15 WEDDERBURN RD, NW3
Proposed Conversion into Three Residential Units for
THE SHIELD GROUP PLC
GROUND FLOOR AS PROPOSED [PLAN]

WB11 E

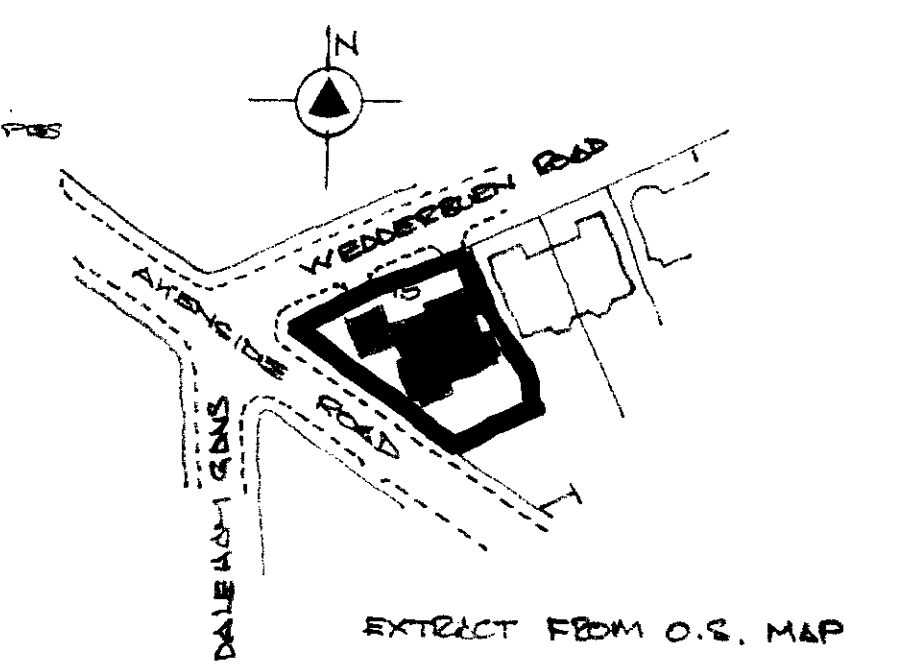
- A ADD NEW CAR PARK FOR UNIT 3 & DEFINE DTDG UNIT 2 & GARDEN 13.1.88
 - B JONES AND NOTES ETC RE BAD PERS APPLICATION 11/2/88
 - C ADD RADIATORS ADD COLDWATER TANK & AMEND WC, ADD VENT FAN ADD FINE VENTILATION TO BEDRM, SHW, GARDEN
 - D ADD NEW ELECTRICITY/SHW EX TO KITCHEN WHERE NEW OR ALTERED FROM ORIGINAL 28/2/88 RETAIN EX. DOOR TO WC SHW-1 HAS D1/14/88 MOVE RAD R1/7 (IN SEE R1/2) ADD VENT FAN TO SHW WC, BN STORE & EX TO ALL UNITS. REINFORCE BED1 FIRE FLOOR AS EX; ADD VENTILATION NOW REQUIRED. REVISE W/DOORS BEDROOM1.
- ADD SITE LOCATION PLAN, TIES & FLOOD OVER INCREASE 11/88
